ElectraNet's Eyre Peninsula Reinforcement Project

ASSESSMENT OF ASPECTS OF THE PROPOSED CAPITAL COSTS

Report prepared for:
**AUSTRALIAN ENERGY
REGULATOR**
September 2020

Figure 5.1: ElectraNet Project Team structure (ECI stage)

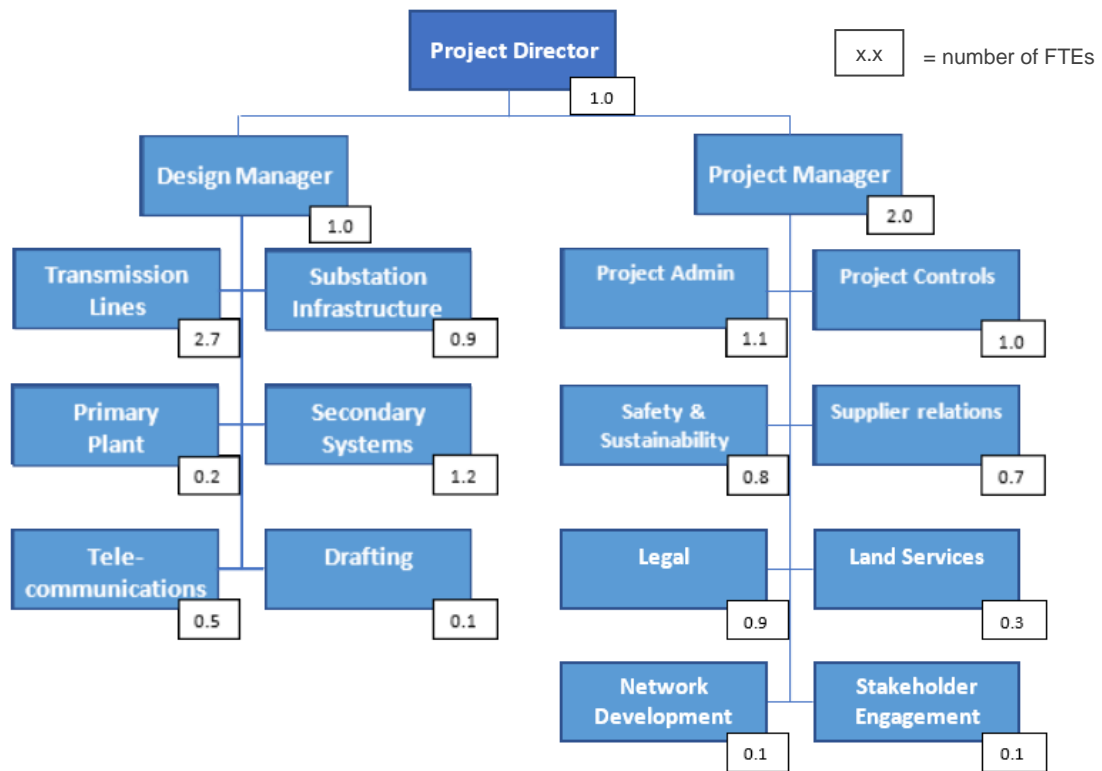
- outage planning; and
 - determination of asset strategies and requirements.
132. We consider that the functions identified in Figure 5.1 are consistent with good project management practice for the scope, complexity, and risk posed by this project.

Figure 5.2: ElectraNet’s Project Team structure (D&C stage)

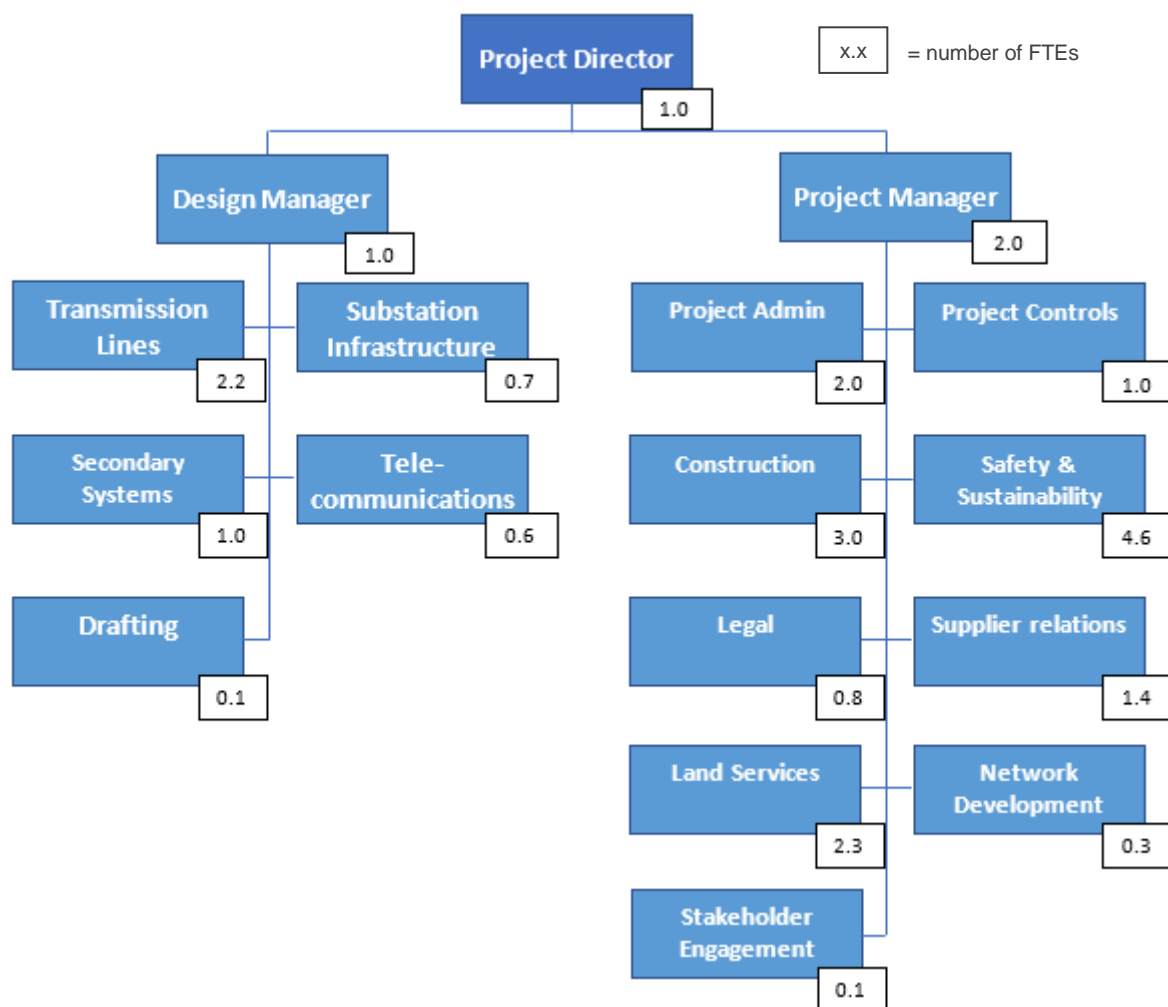
147. EN advises that the costs shown in Table 5.5 are internal labour estimates and have been or will be captured by direct timesheet bookings to the project – so partial FTEs should not be double counting costs to the project. This is consistent with good industry practice although allowance for periodic audits of the bookings to the project should be undertaken to provide assurance that the cost is efficient.
